## Product Change Notification / ALAN-24BGXP256

CCB 4661 Initial Notice: Qualification of STAR as an additional assembly site for selected DSC812xxx, DSC110xxx, and DSC112xxx device families available in 6L VDFN (7x5x0.9mm) package

## Pre and Post Change Summary

### PCN# ALAN-24BGXP256

## Pre Change

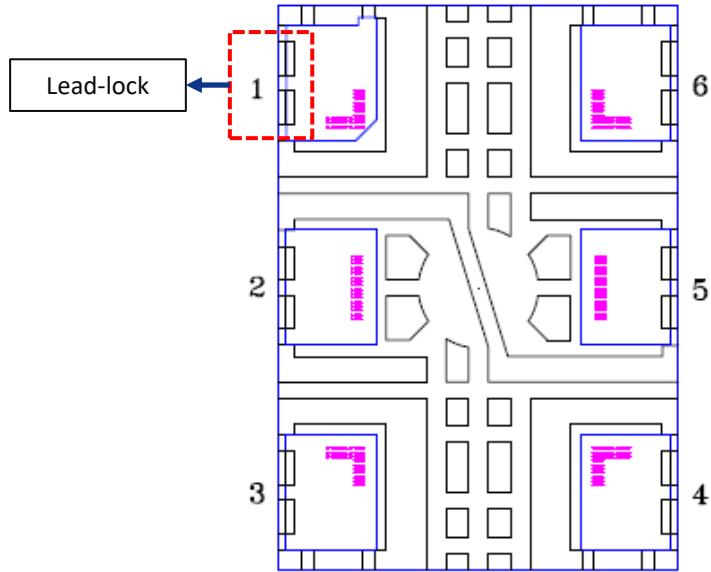
Assembly Site	NSEB
Lead-lock	Yes
DAP Surface Prep	Selective PPF

## Post Change

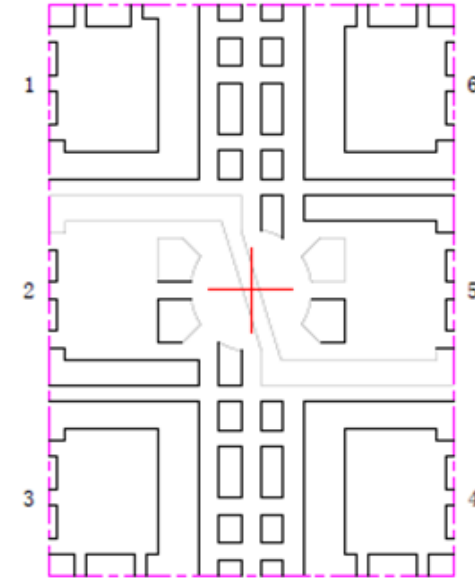
Assembly Site	STAR
Lead -Lock	No
DAP Surface Prep	Full PPF
